**CITY OF PORTLAND, MAINE  
DEVELOPMENT REVIEW APPLICATION  
PLANNING DEPARTMENT PROCESSING FORM  
DRC Copy**

Single Family Home

- 1 A COPY OF THE NEWLY RECORDED FALL BROOK SEWER EASEMENT SHALL BE DELIVERED TO THE CITY PRIOR TO ISSUANCE OF A CERTIFICATE OF OCCUPANCY.
- 2 Two (2) City of Portland approved species and size trees must be planted on your street frontage prior to issuance of a Certificate of Occupancy.

SCALE: 1" = 40'

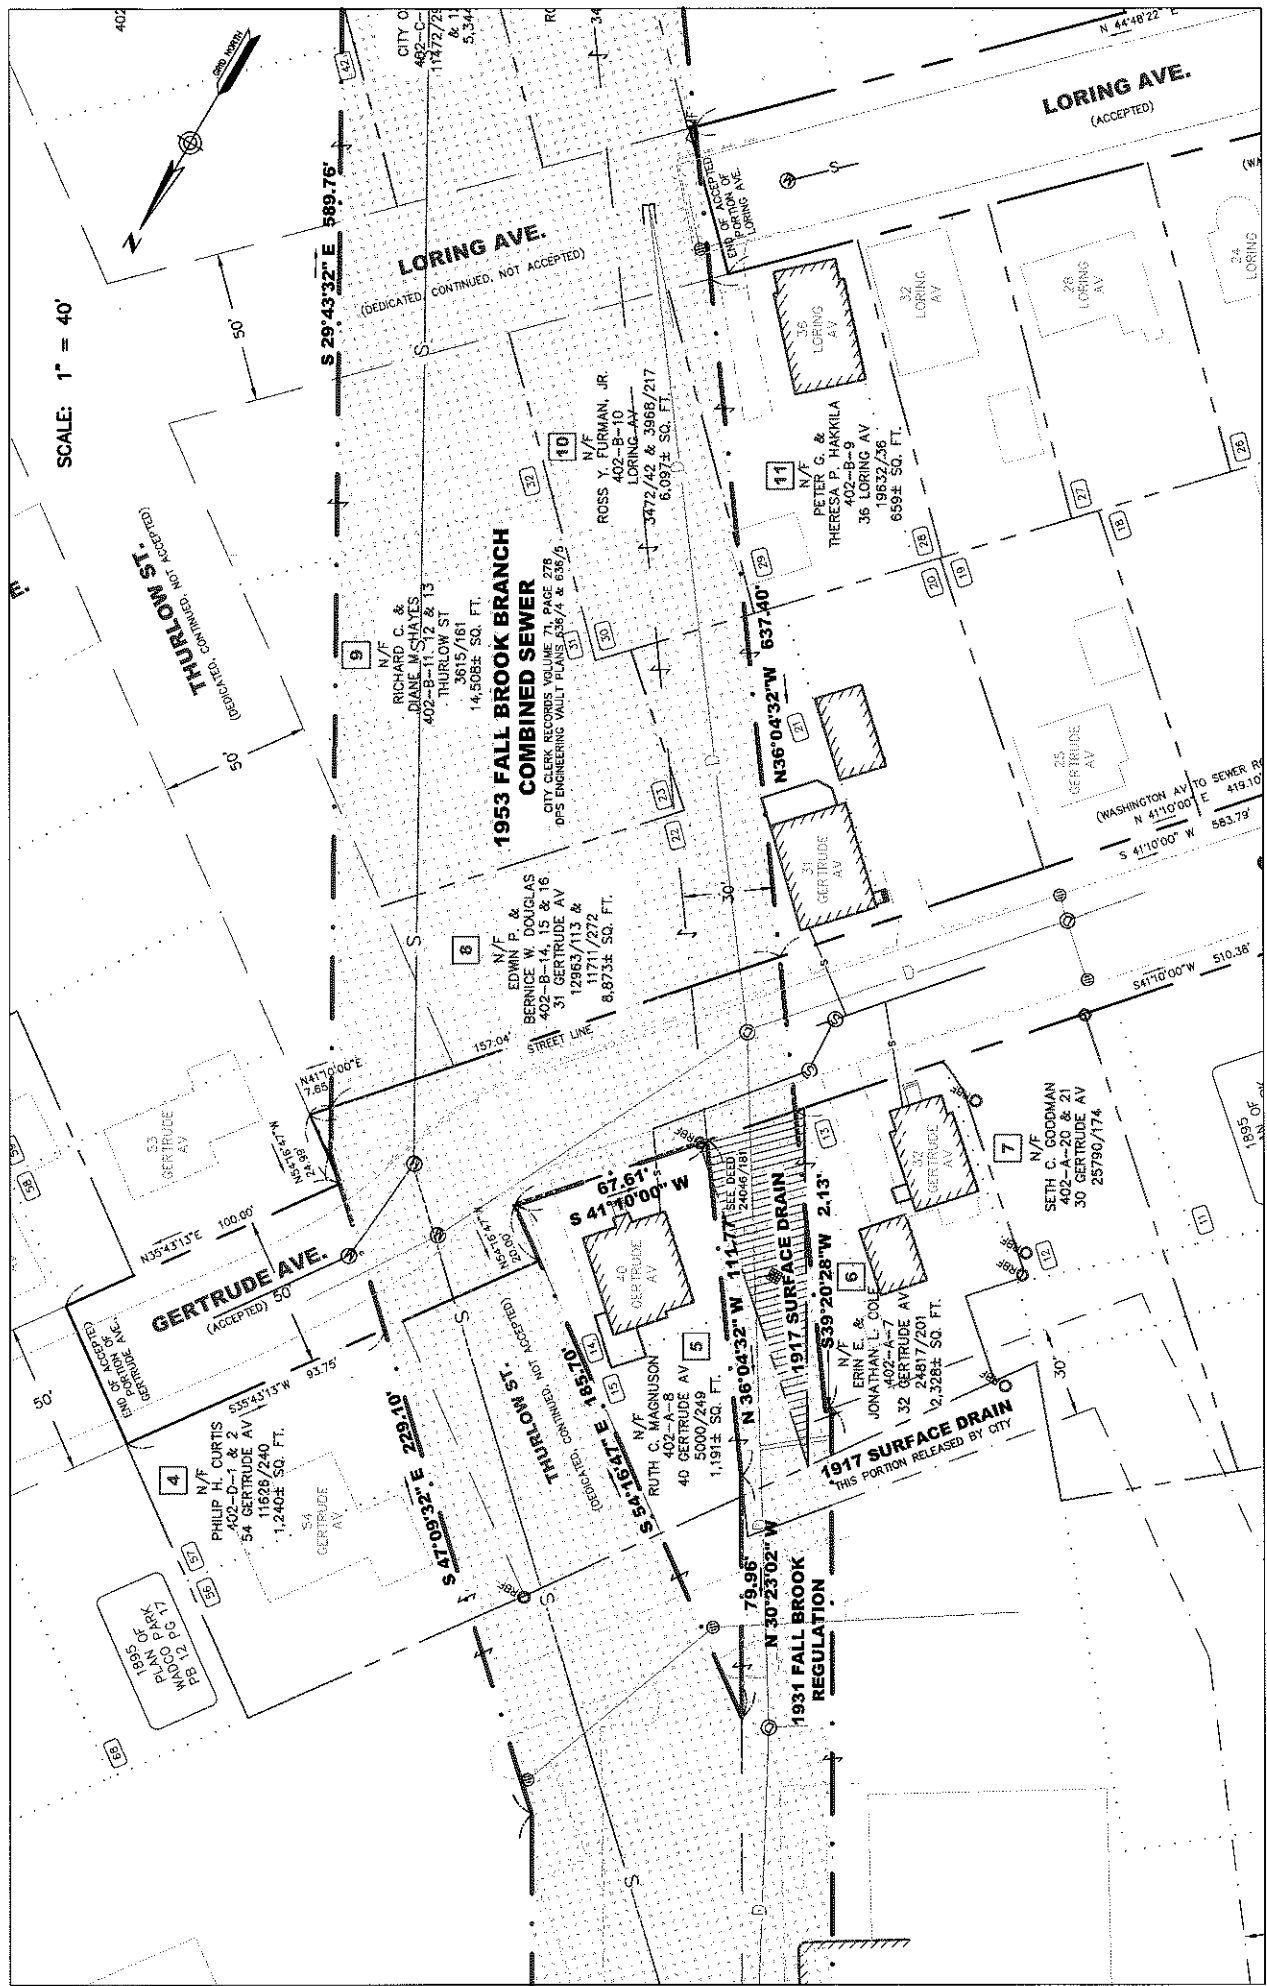
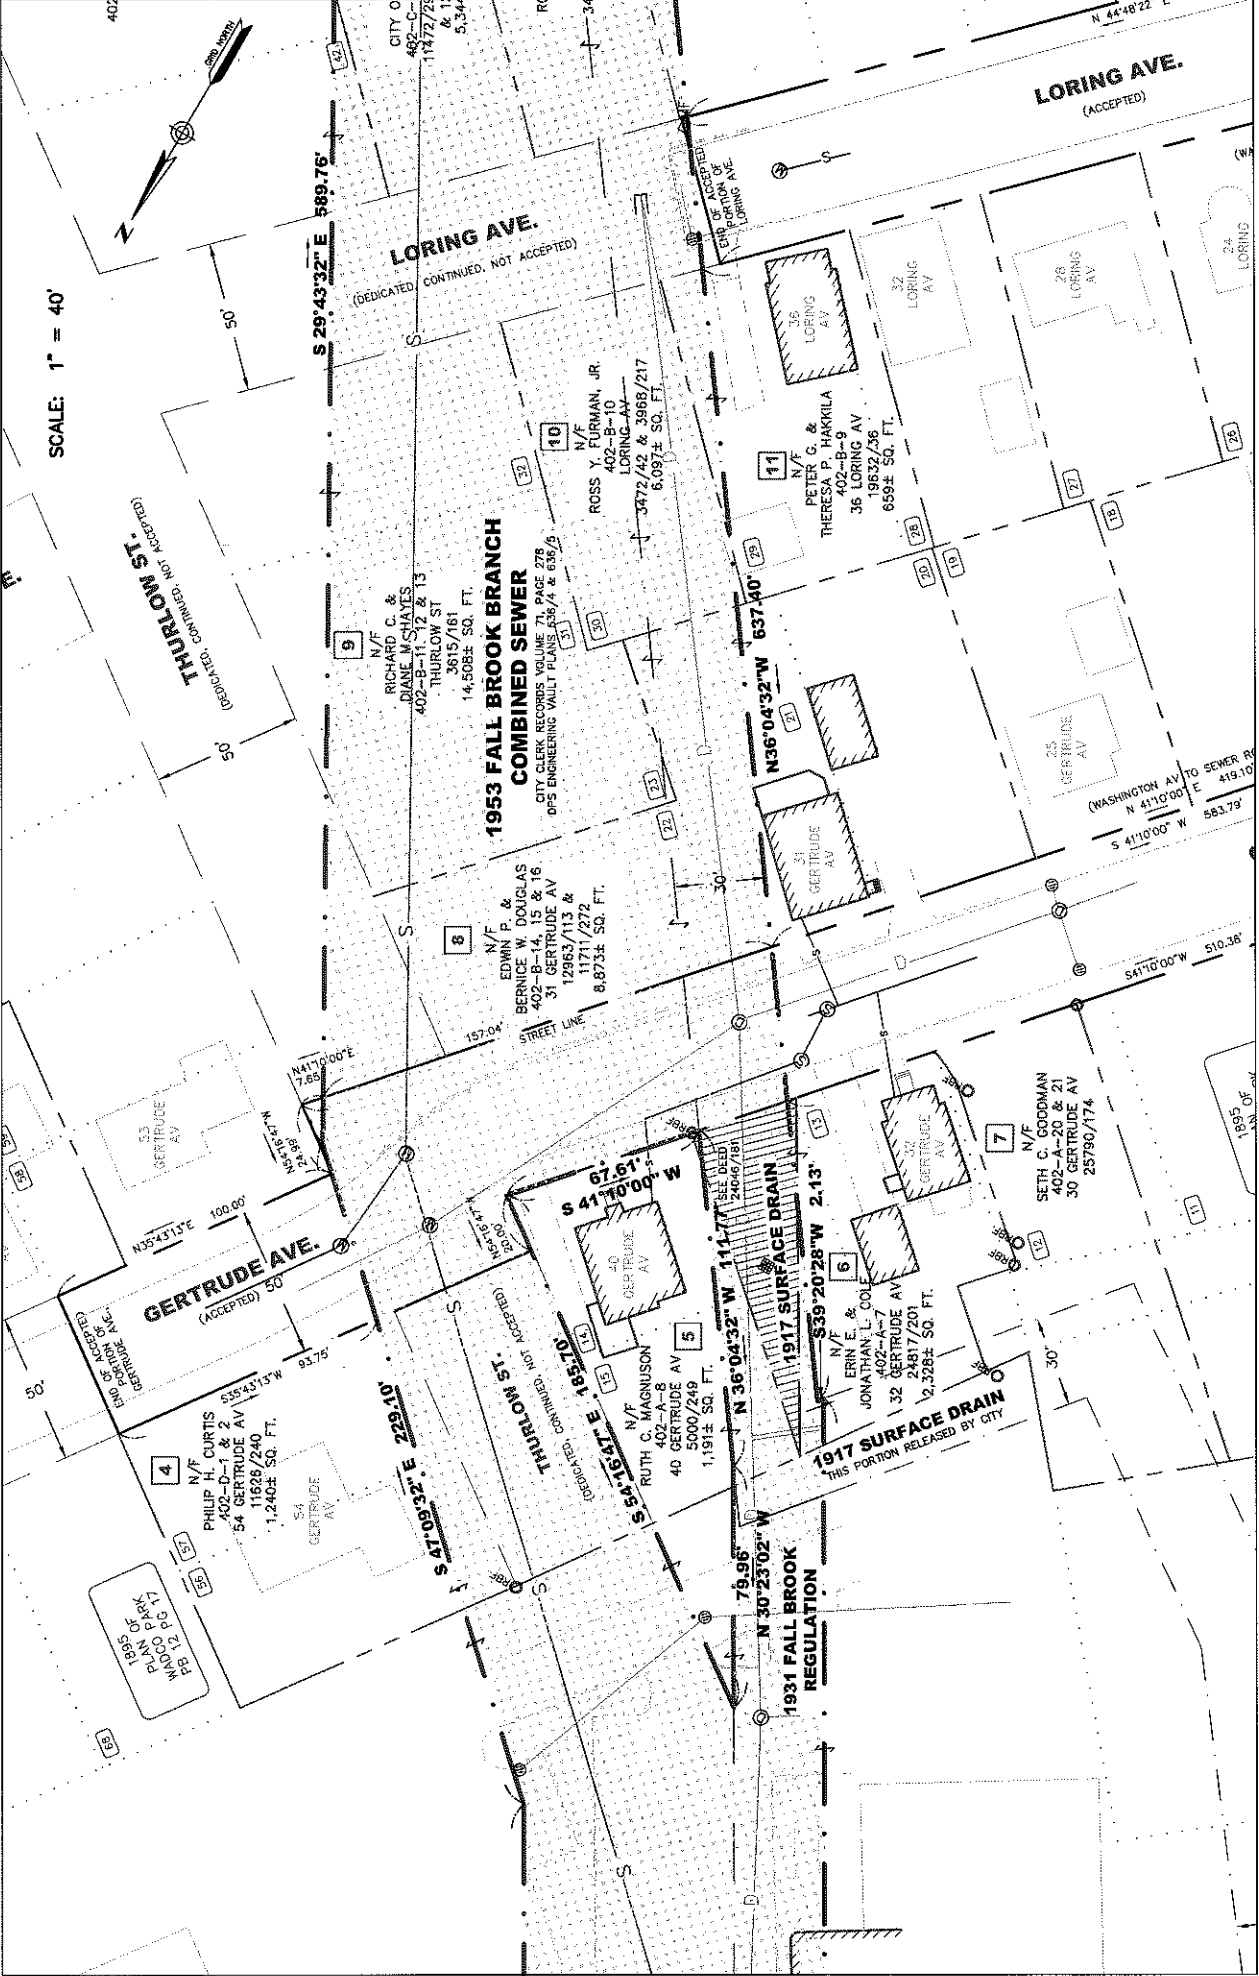
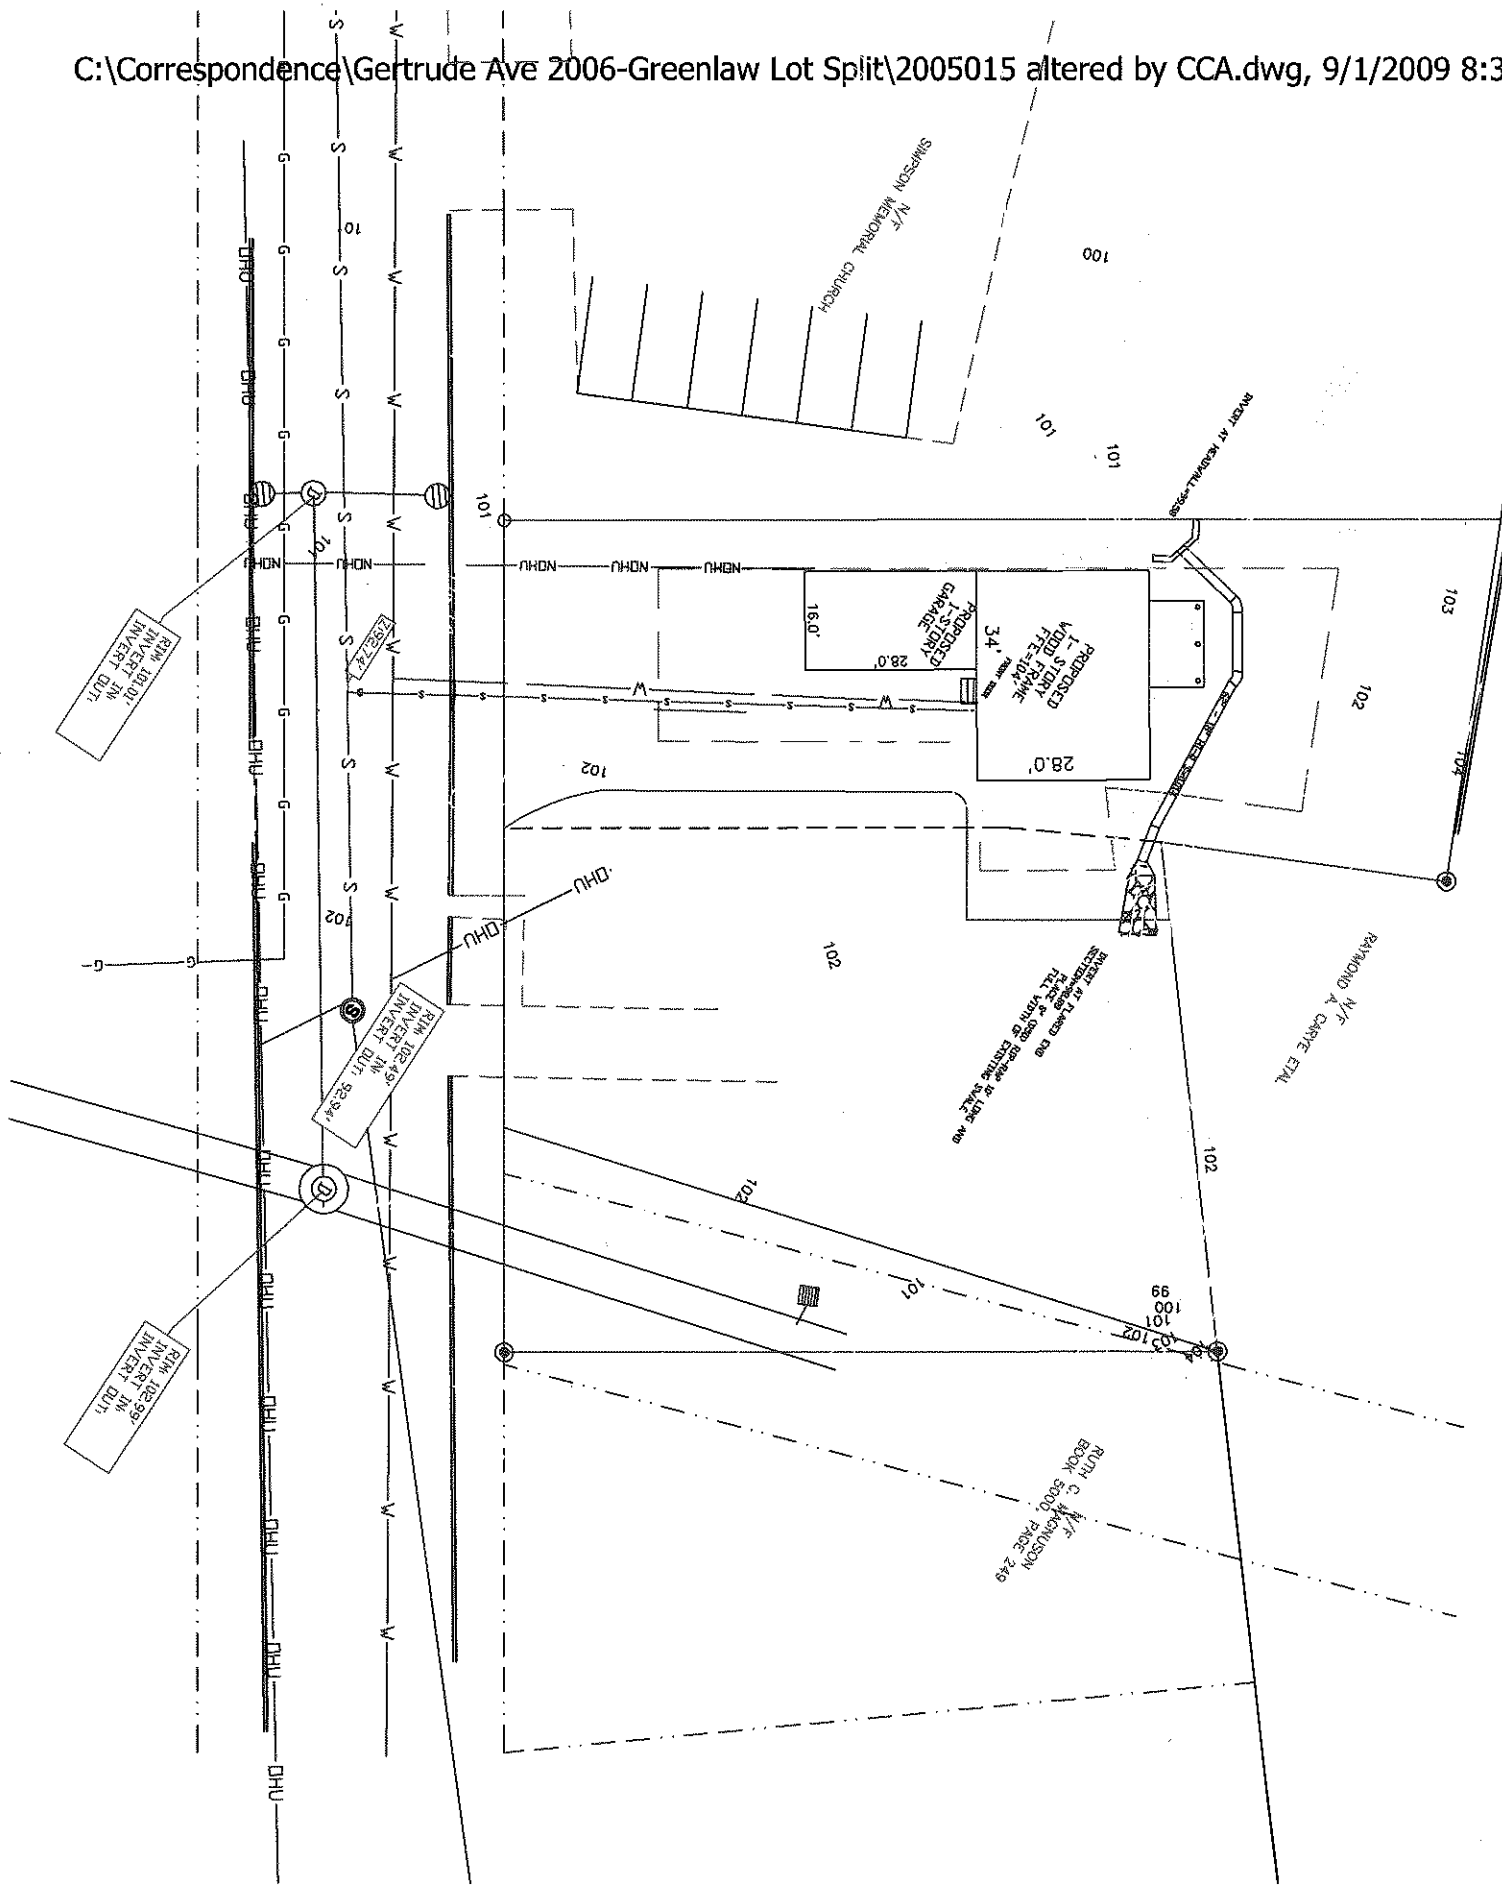
**Penny**, Per our informal conversation this morning in the reception area at Public Services: I've pasted some of the past emails that help to explain the situation. Please see attached plans as they are necessary to understanding the problem. My question is this - **Is there anything that planning can do retroactively to remedy this situation?** **Barbara**, this email is in response to the voice mail message I left yesterday. From: Camille Alden To: Norman Twaddel Date: 9/1/2009 10:52:59 AM Subject: RE: Drainage Issue at 32 Gertrude Jonathan Cole John (Emerson), If you look at the City's plan that I gave you last week (also attached herein), you can see that the inlet pipe (double golden line) is at the southwesterly edge of the City's r/w. Anything southwest of that inlet pipe is outside the City's r/w. As you've witnessed, and as Cole has confirmed, the inlet pipe is taking all the water that runs into it. The pipe is not plugged. As mentioned before, and as you have noticed out in the field, all the water from the church and all the water from the "new" house lot drains over 32 Gertrude (Cole's Lot) towards the inlet pipe that is within the City's r/w. I've attached Bob Greenlaw's site plan (w/a few color changes made by myself to clarify the issue) to illustrate the following points. This is his proposed site plan and may or may not match what is actually on the ground. \*\*\*The Church has an easement over the "new" lot up to the dark blue dashed line, but not beyond it.\*\*\*The Cole's deed states that the Church has a drainage easement over their lot, but that easement only extends from the Church and up to the blue line.\*\*\*As you can see, the proposed drainage over the "new" lot extends onto Cole's property. (I do not know if the drainage was actually constructed per design.)\*\*\*The proposed contour lines are in "boxes". It is obvious that minimal contour changes were made as part of the lot split.\*\*\*My deed research indicates that the "new" lot does not have a drainage easement over Cole's property. This drainage easement should have been created at the time of the lot split, unfortunately, it was not.\*\*\*Please note that Mr. Greenlaw's City r/w line does not in any way agree with the location of the r/w line shown on my plan. If the inlet pipe is

working fine and the drainage swale within the City's r/w is running water smoothly to the inlet pipe, then it's not clear to me how this can be a City issue. Again, this appears to be a private issue. I'd be happy to discuss this with you in person if you'd like. It is sometimes easier with plans in hand. Camille Camille C.

Danielle and I have looked at what you sent over and looked at the file we have on this single family application. It appears that the new lot was split from a lot that included an existing single family home and it appears that it was all under one ownership at that time. A drainage easement was not required as part of the review at that time. The City plans shows a 1917 Surface Drain along the rear property line, but it is noted as being released by the City.

It appears that this is a private dispute. I defer to Penny in case she knows of some other approach to this matter.
